ORIGINATION FORM

Proposed Revisions to a Standard Plans Index

Index Number: 521-650

Index Title: Light Pole Pedestal - Wall Coping

TABLE 1 DESIGN LIMITATION FOR ANCHOR BOLTS (1" Dia.)

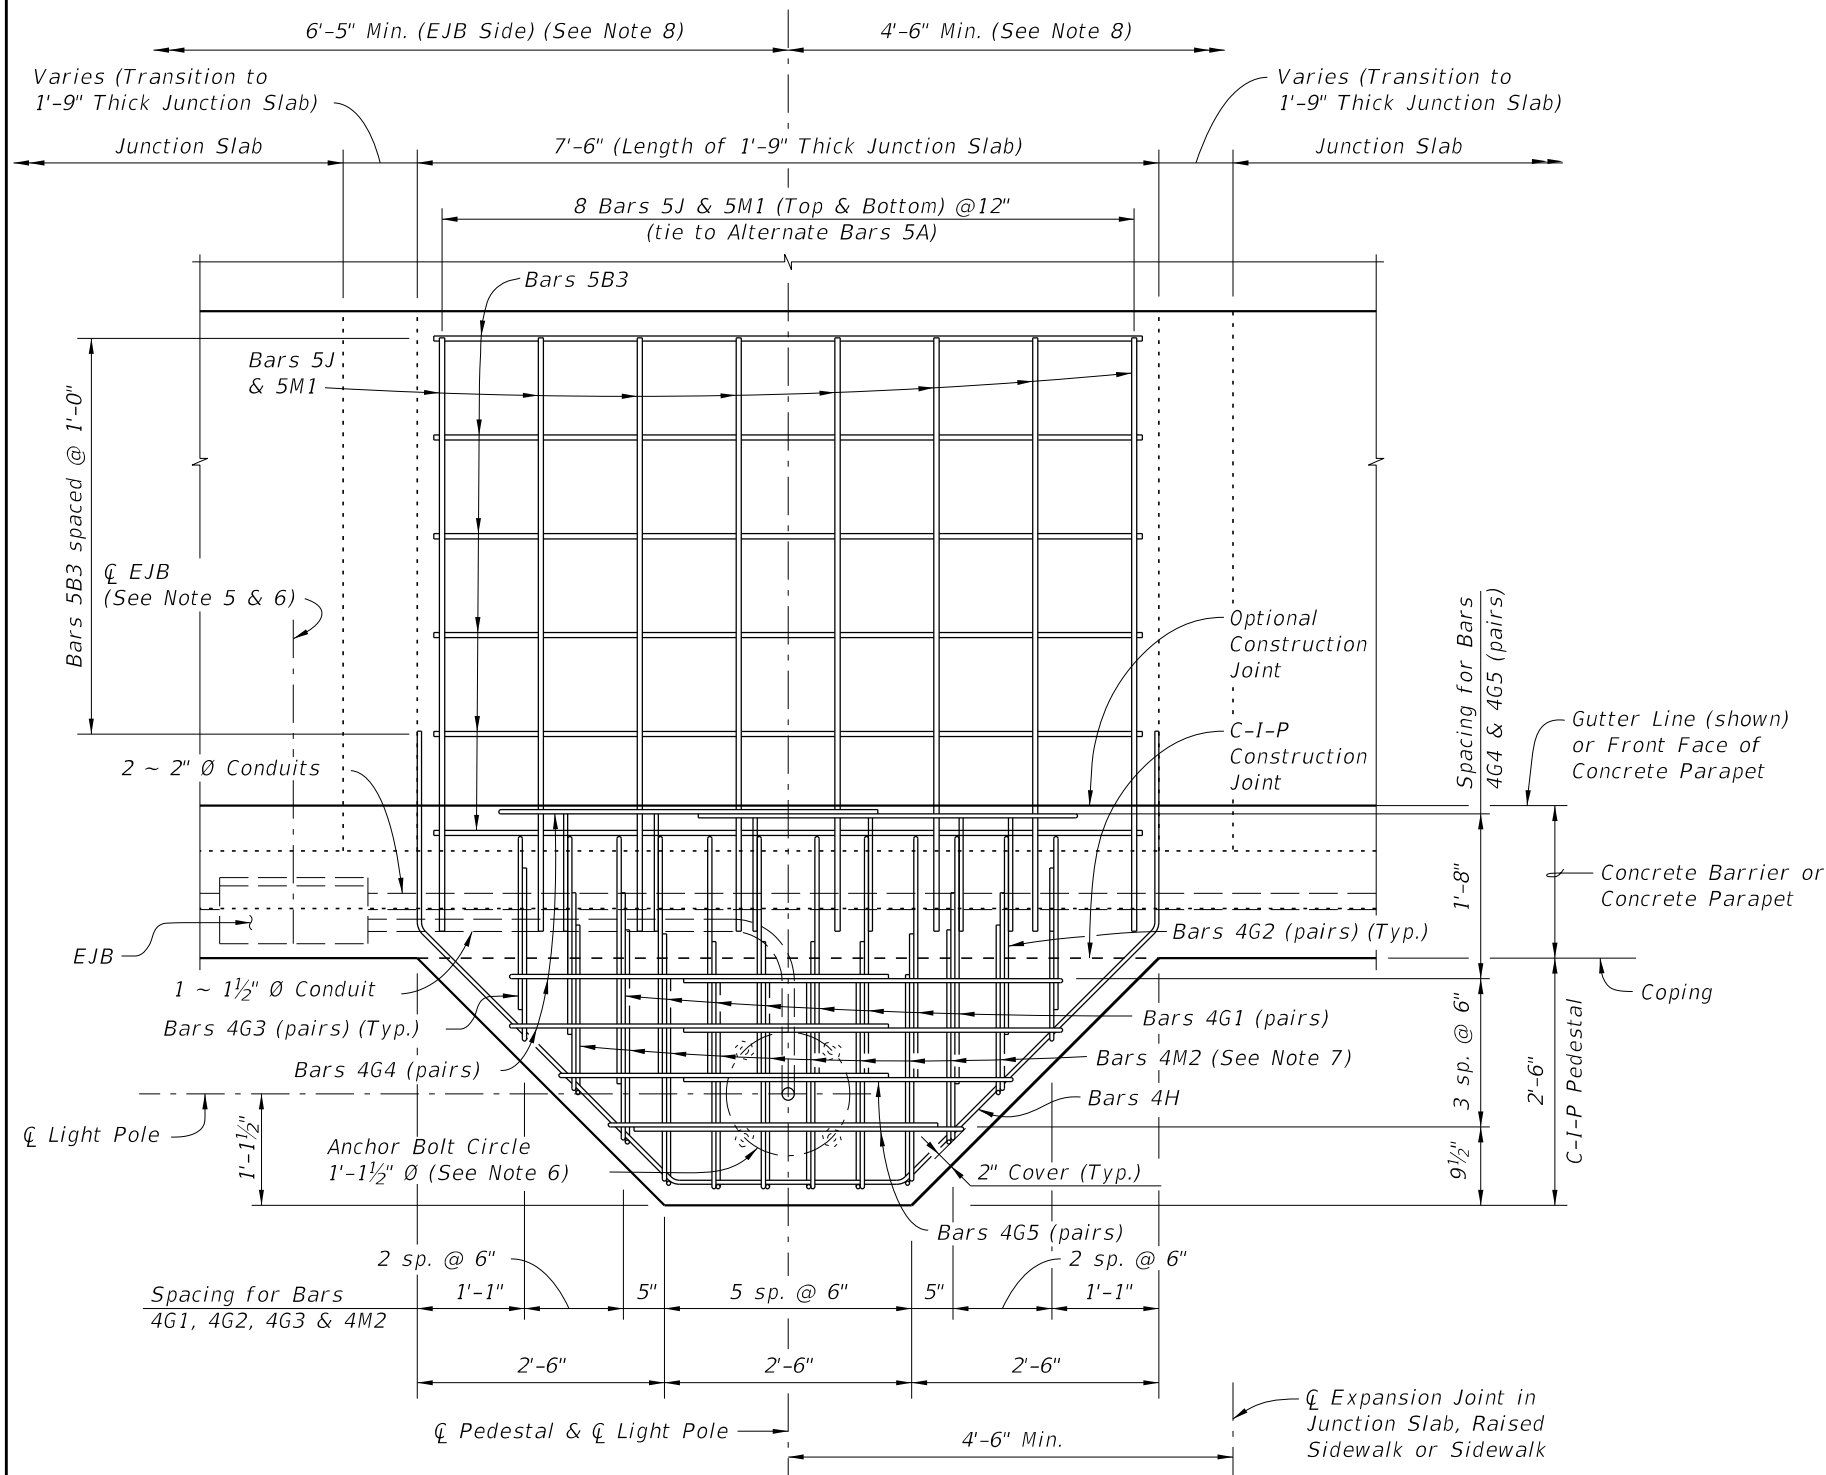
Sheet 1: Table 1 - Changed the column headings to "Top of Pedestal Height (Ft.)" and "Luminaire Mounting Height";
Note 10 - Added Index 521-611 reference

Sheet 1: The Table 1 column headings were revised to better define the height restrictions shown

Top of Pedestal Height (Ft.)*
 Luminaire Mounting Height

DETAIL "A"

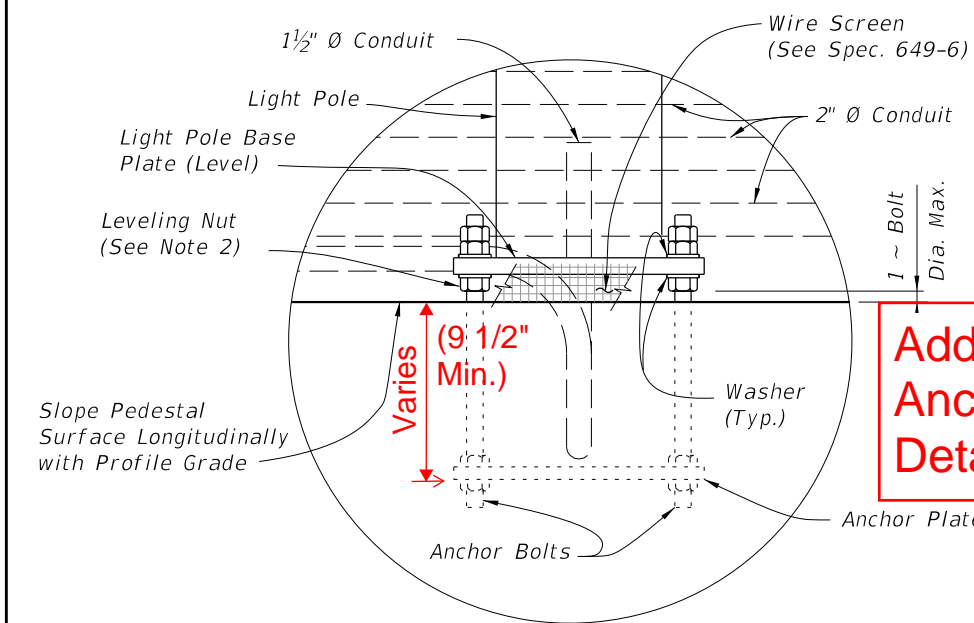
Sheet 3: Detail "A" - Added minimum depth for base plate; Added new Anchor Plate Detail

Sheet 3: More information was provided to clarify the anchor plate design and placement. The new anchor plate detail is based on Index 521-660, Sheet 4.

Added new Anchor Plate Detail
